# **OFFICIAL MEETING NOTICE AND AGENDA**

**RE: Exclusively Roses Inc., 221 Business Park Circle – Building Addition**

I have completed a final review of the proposed building addition for Exclusively Roses, 221 Business Park Circle, Stoughton, WI. 53589 – plans received 12/12/14. A joint meeting of the Planning Commission and Business Park North Committee will be on Monday December 15, 2014 of which you will receive notice.

**EXCLUSIVELY ROSES - BUILDING ADDITION**  
 TURNING TEMPLATE PLAN  
 PAGE: 4 OF 4  
 DATED: DECEMBER 11, 2014

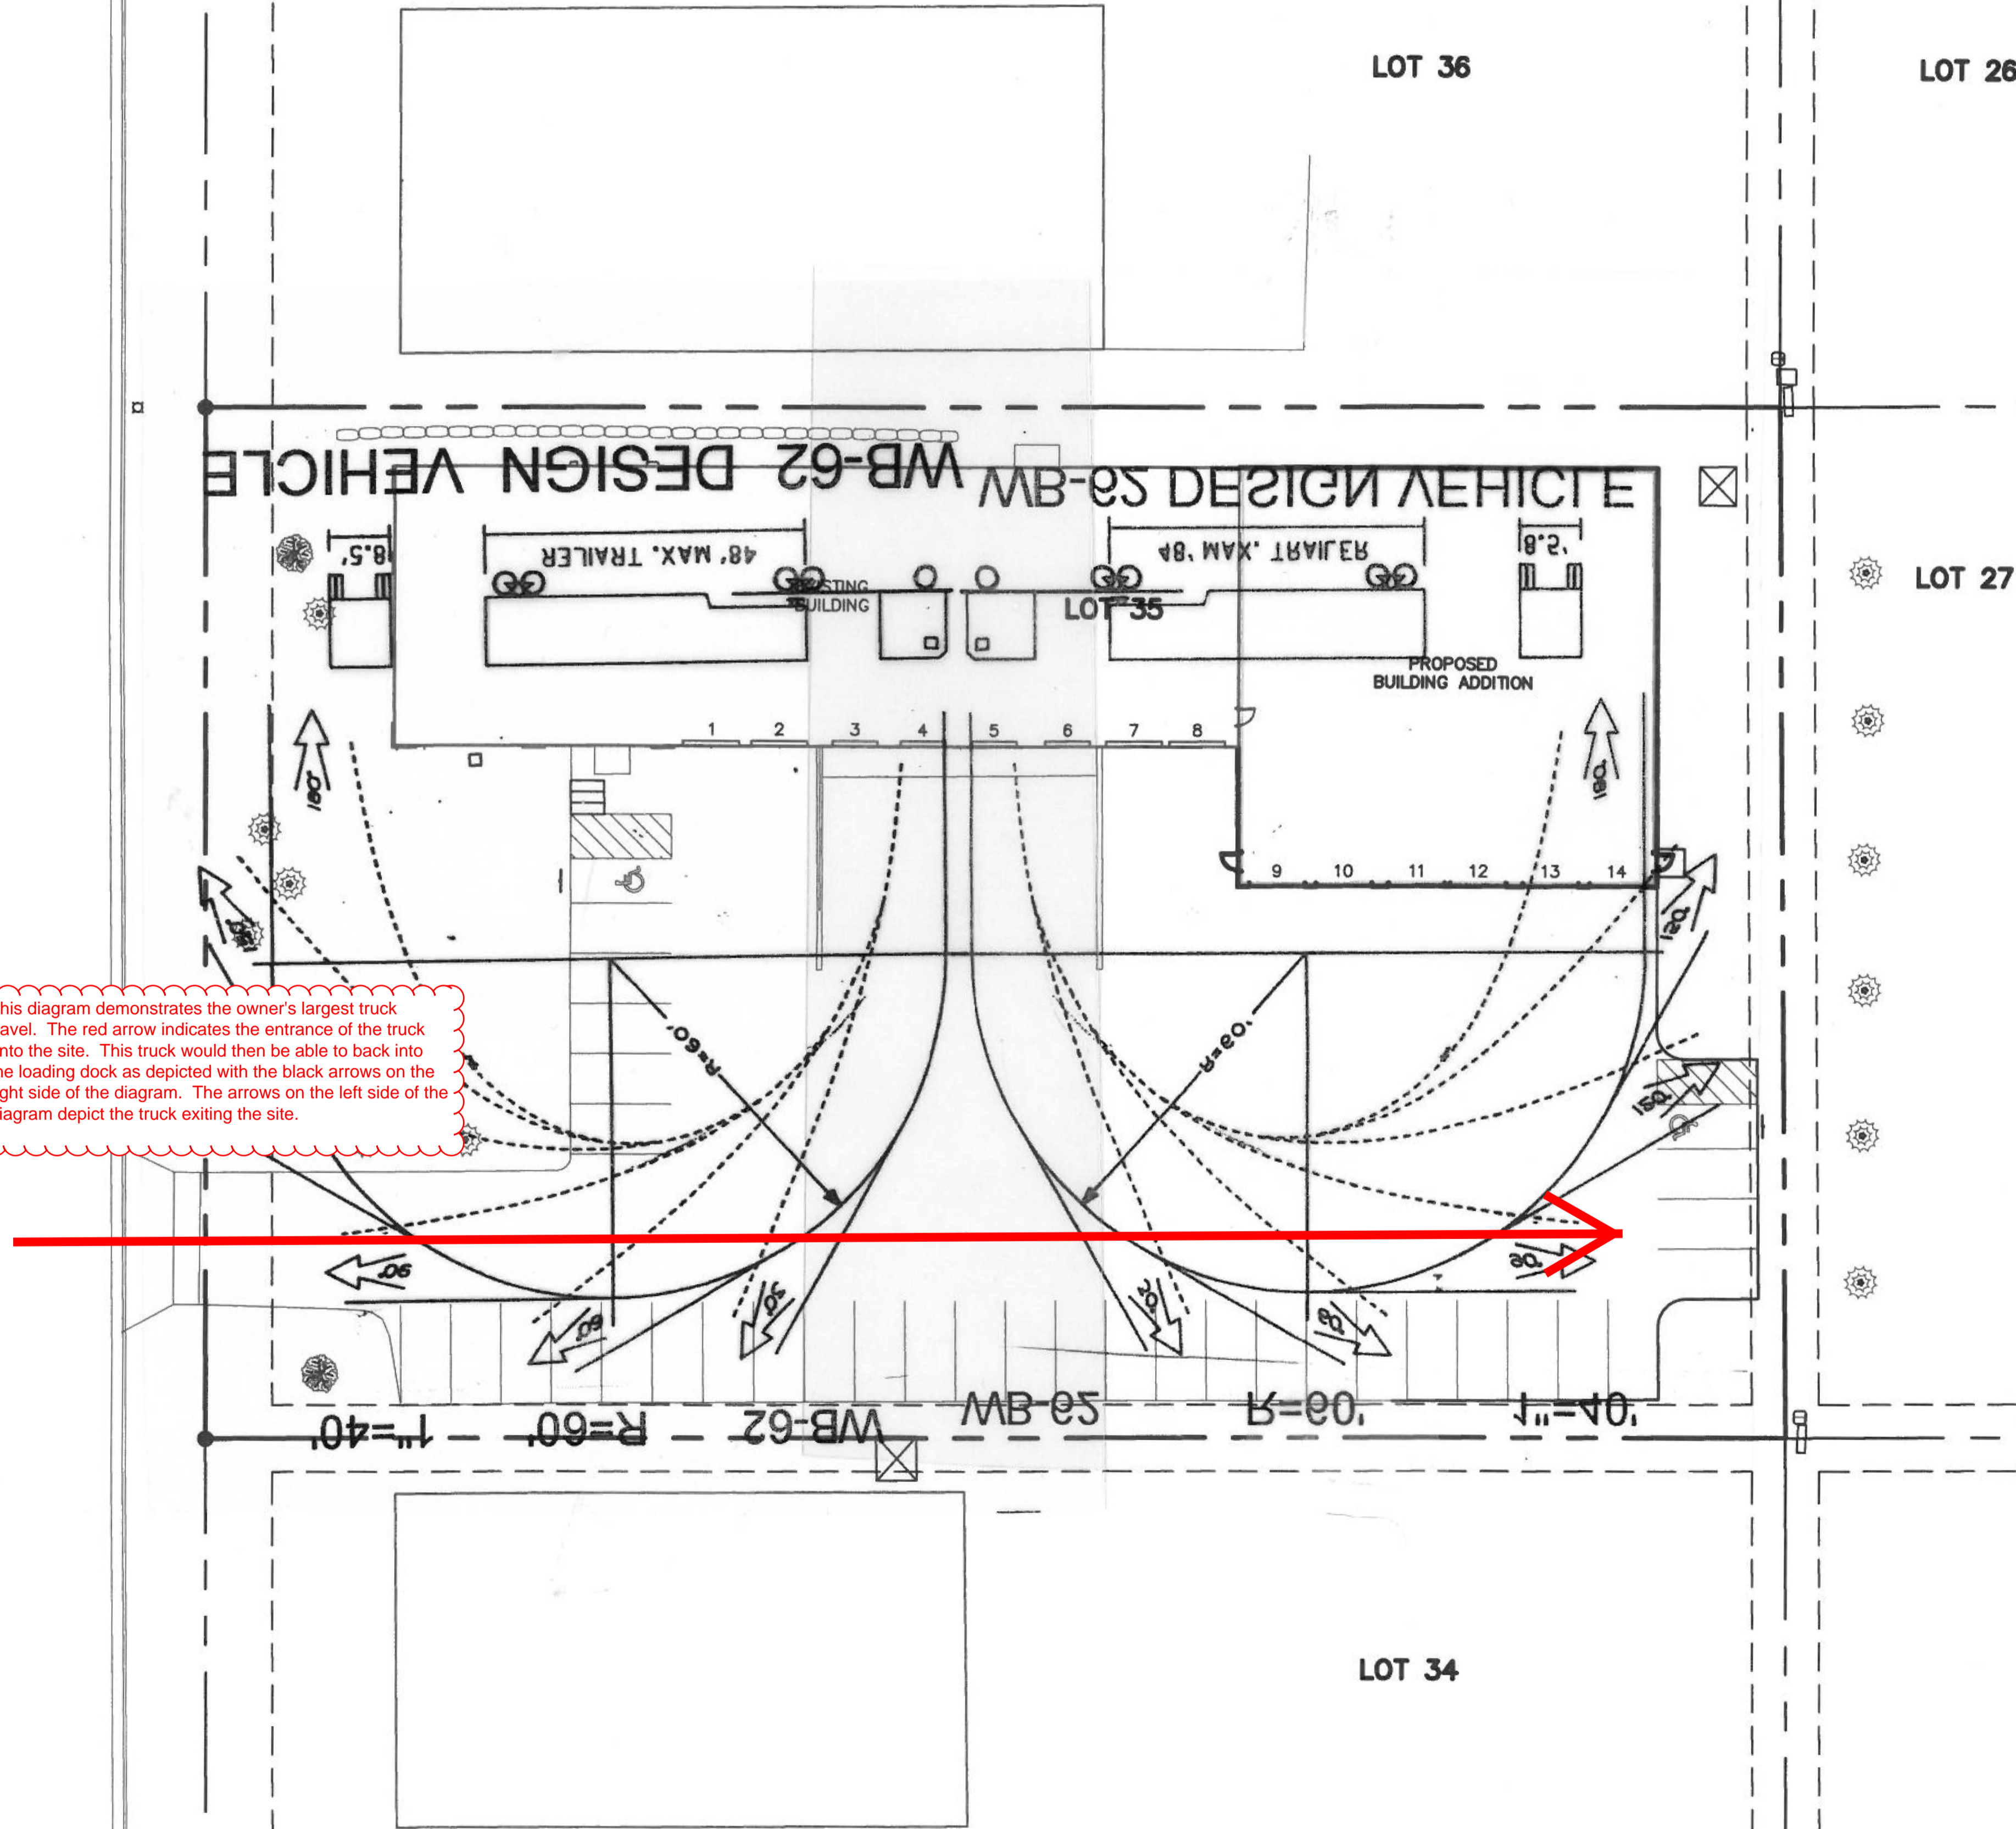
17. Off-street loading stall requirements per section 78-705. **A diagram has been provided detailing how trucks will be able to maneuver onsite. Backing into and from the street is not allowed. The site must also meet the loading standards as provided in Table 78-705(4) per the zoning code. The truck turning template appears to indicate trucks will need to use employee parking spaces and areas beyond pavement. It does not appear easy for a large truck to maneuver onsite and could cause a driver to back into and/or out of the site. This will need to be discussed.**

Pole Schedule  
(2) PS4S20SC1XX (20' X 4" X .125" STEEL SQUARE POLE)  
Proposed poles meet 130 MPH sustained winds.

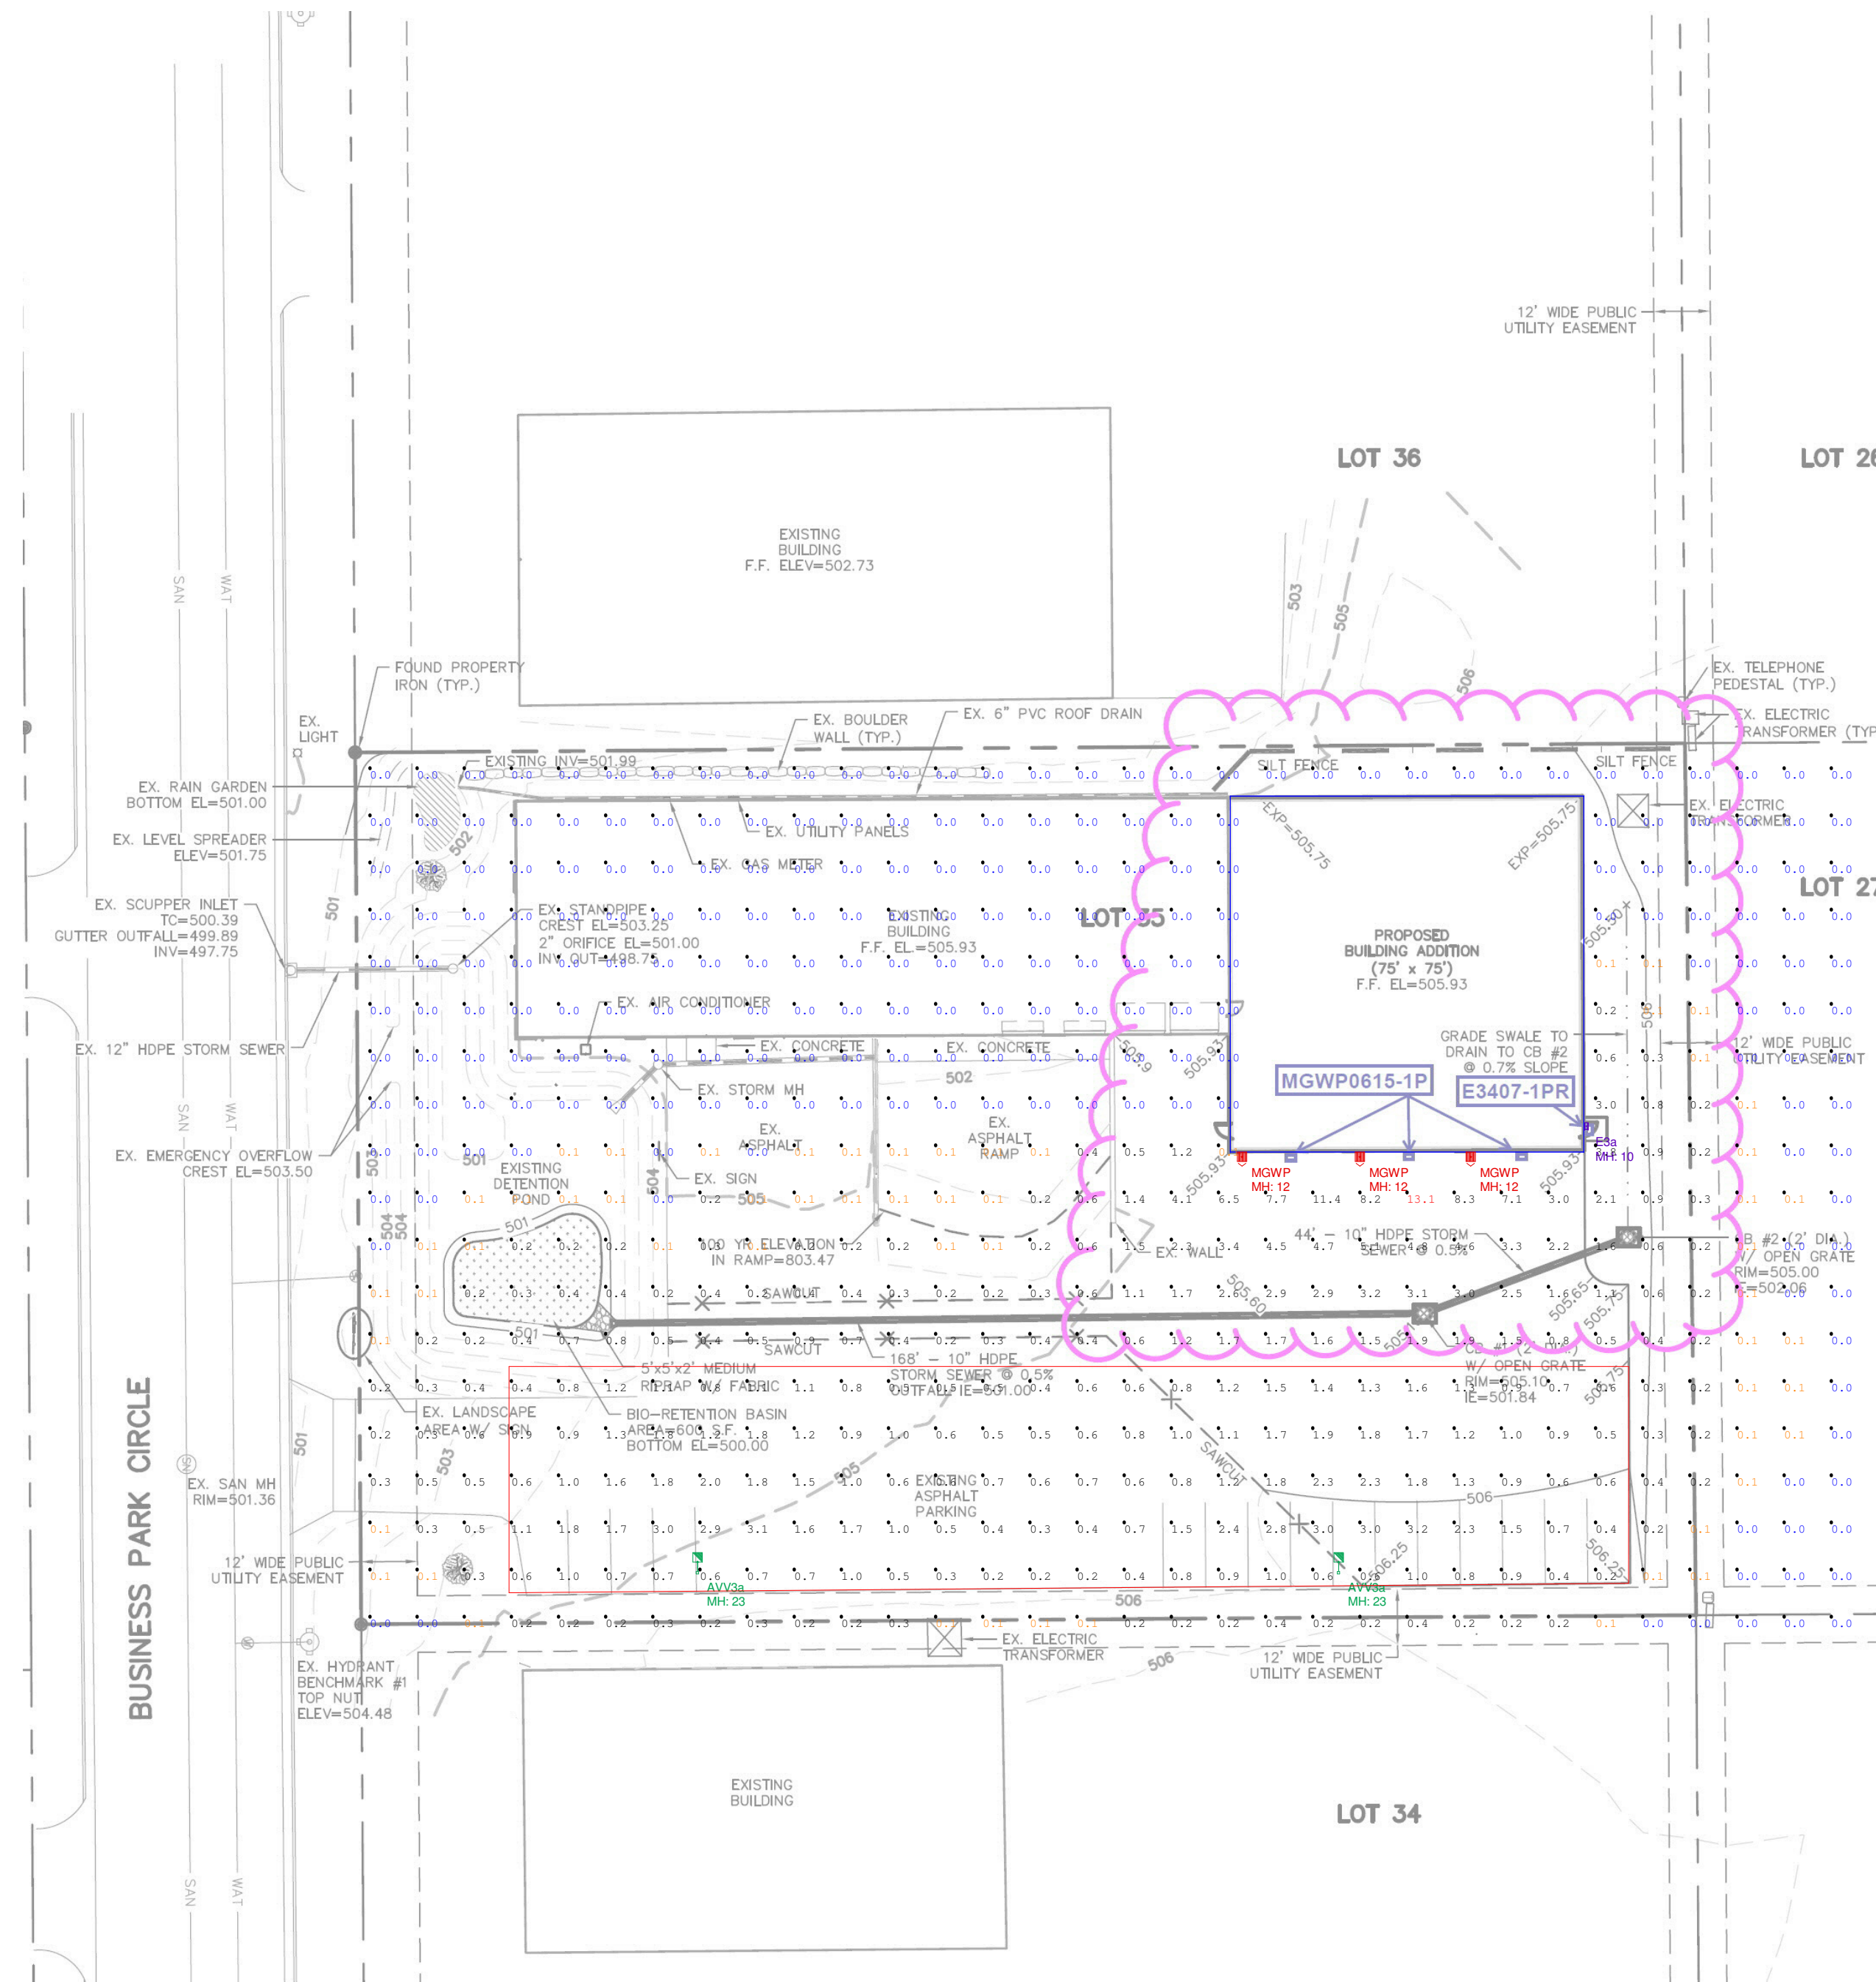
All off-street parking areas shall be lit to ensure safe and efficient use. An illumination level of between 0.4 and 1.0 footcandles are recommended and said illumination shall not exceed the standards of section 78-707. The maximum lighting as measured at the property line is 0.5 footcandles. The maximum average on-site lighting shall be 2.4 footcandles. The minimum lighting standard for parking areas used after sunset shall be 0.2 foot-candles. The lighting element shall not be visible from the residentially zoned properties. **A compliant photometric plan has been provided.**
